SUBJECT: CERTIFICATION OF THE MINUTES OF THE ACRS FUTURE
 PLANT DESIGNS SUBCOMMITTEE MEETING MARCH 1, 2016,
 IN ROCKVILLE, MARYLAND

ADVISORY COMMITTEE ON REACTOR SAFEGUARDS
MINUTES OF THE FUTURE PLANT DESIGNS SUBCOMMITTEE
MEETING ON MARCH 1, 2016

The purpose of the meeting was to review the NuScale-submitted topical report on risk determination methodology (NuScale Licensing Topical Report TR-0515-13952-NP, Rev. 0, "Risk Significance Determination," July 2015 (ML15211A470)), the NRC staff's review of it, and NuScale's plan to use this methodology in their design certification application for their design of the small modular reactor that uses integrated pressurized water reactor (iPWR) technology. The meeting transcripts are attached and contain a description of each matter discussed during the meeting. The presentation slides and handouts used during the meeting are attached to these transcripts.

RG 1.174, Figure 4

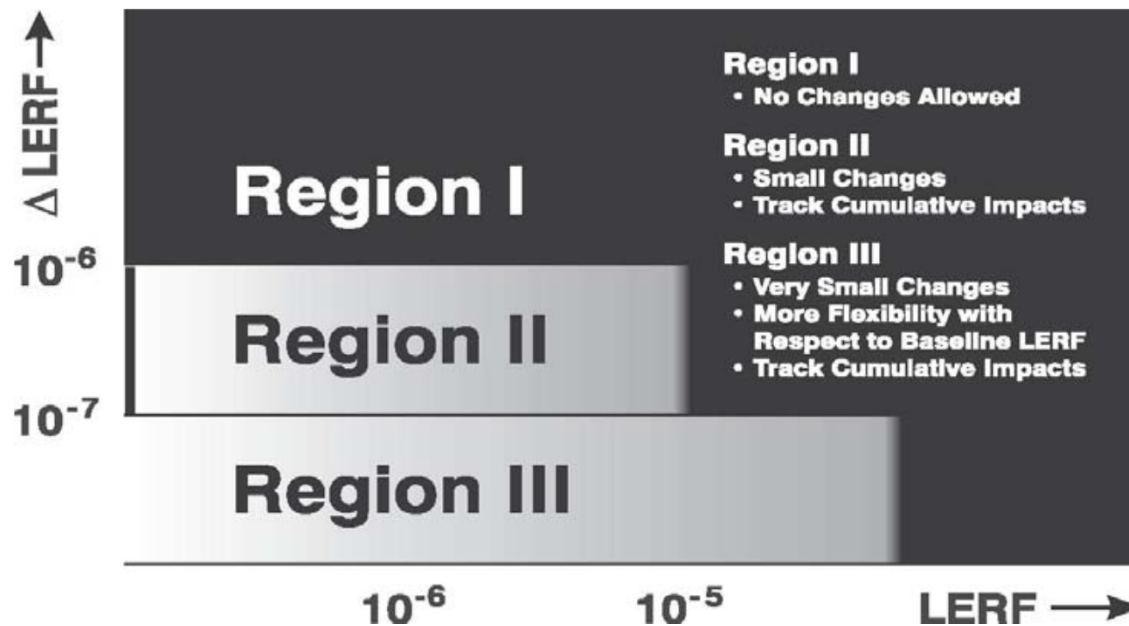
20 Then the -- this is the chart or the
21 figure that shows the core damage frequency
22 thresholds which depending on the base case core
23 damage frequency, there are different levels of --
24 I won't call them acceptability, but different
25 levels at which the -- they will be considered as

2 So, in this case, I want to point out
3 that if a plant has a core damage frequency of on
4 the order of 10^{-5} , then anything
5 less than a delta CDF of 10^{-5} would
6 be considered as acceptable or -- yeah, that's
7 right, considered.

19 CHAIR CORRADINI: So, I'm going to let
20 John understand that answer. I want to go back to
21 in the figure you have, you talk about LERF, but
22 we're talking LRF. So, they're not one in the
23 same.
